PART NUMBER		ABM100-AV		
TITLE		VHB ADHESIVE BACKED MOUNTS		
ITEM REVISION NAME		CUSTOMER DRAWING		
DATASET FILE NAME		00202BBC/00		
		00202BBC_DC_ABM100-AV/00B		
MATERIAL		NYLON 6/6		
DRAWING NUMBER		00202BBC-DC		
THIRD ANGLE PROJECTION				
DRAWN BY	DATE	CHK	SCALE	SIZE
BDK	10.09.20	DAEI	NTS	A
REV	DATE	BY	CHK	APR
00	10.09.20	BDK	DAEI	MBVE
00B	03.15.21	BDK	MRJS	JADE

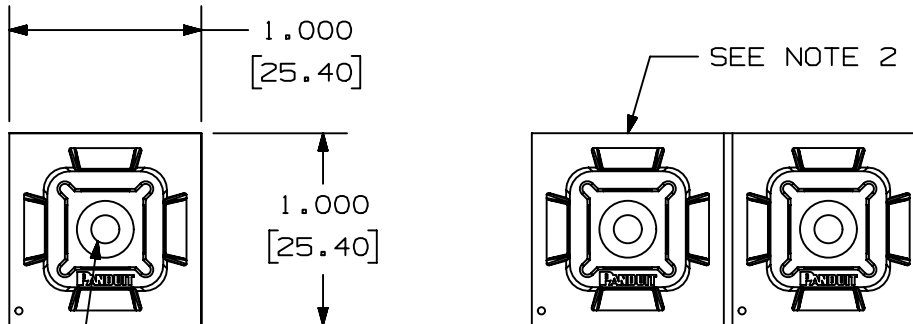
**A:** REVISED APPLICATION STEPS  
**B:** CHANGED DIMENSION ORIGIN  
**C:** CORRECTED SUPPORT WEIGHT; TAPE THICKNESS WAS 0.027 [ 0.69 ]  
**D:** TEMPERATURE WAS 120°F (49°C)  
**E:** MINIATURE WAS MEDIUM; REMOVED SG100M AND SG150I
